# Access Compliance Report

## Public Rights-of-Way

| Intersection ID: 49289                  | Main Street: ARDREY_CREST_DR | Cross Street: ELIZABETH_CREST_LN        | Location: SW           |
| ADA ID: E15D7800BBE0                    | Ramp Type: Perp              | Initial Pass/Fail: Fail                 | Overall Compliance: No |

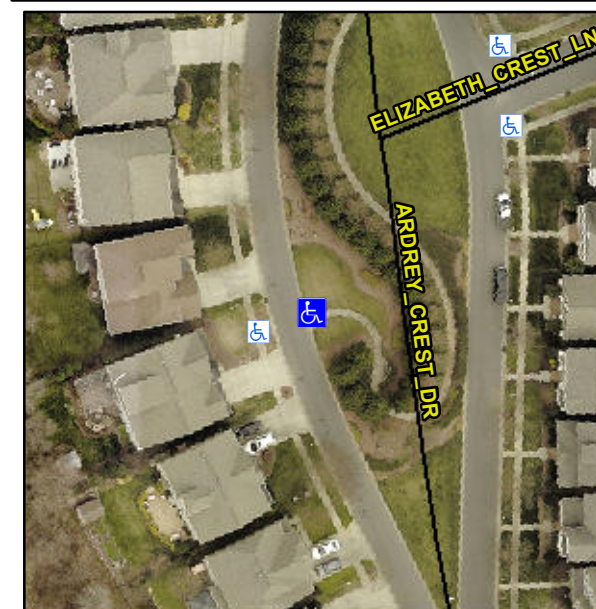
**Not Found, R304.5.1**

| Compliance | Description           | Data  | Compliance | Description                 | Data |
|------------|-----------------------|-------|------------|-----------------------------|------|
| No         | Ramp Width (in)       | 47.0  | Yes        | Ramp XSlope (%)             | 1.3  |

**Remove & Replace Entire Ramp.**
